SERVICE BULLETIN

APPLICABILITY: 2015MY Legacy and Outback Models Equipped with 3.6L Engine **NUMBER:** 11-152-14
SUBJECT: DTC P0456 / Clamps Added to Canister Purge Control Solenoid Valve Hose **DATE:** 12/15/14

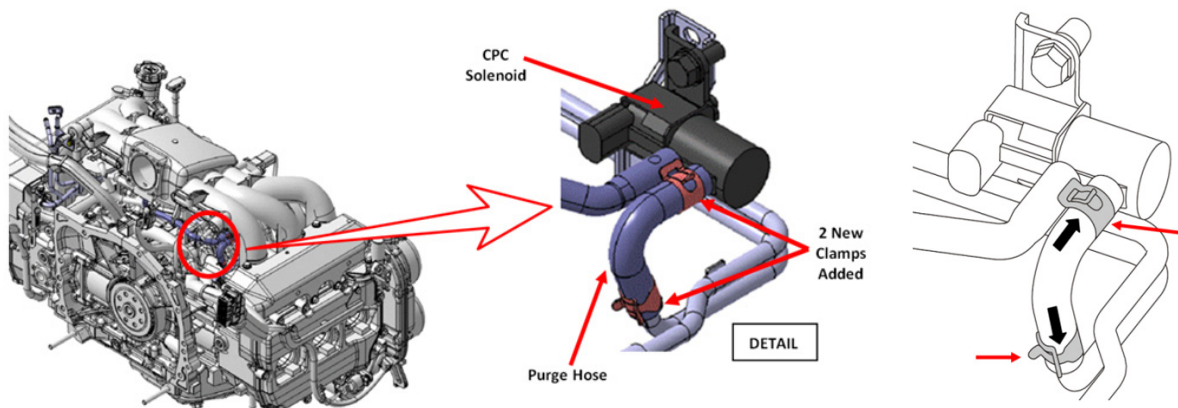
This bulletin announces a production change involving the addition of spring clamps to both ends of the canister purge control solenoid valve hose. In some cases, a small leak at these hose connections could result in a Check Engine Light (CEL) illumination with DTC P0456 stored in memory.

CAREFULLY remove the engine upper cover to gain access to the CPC solenoid and hoses. Install a new spring clamp on both ends of the CPC solenoid valve purge hose as shown below.

IMPORTANT: The ends of the spring clamps must be oriented on the purge hose as shown in the 2 illustrations to the right below to avoid interference with other components.
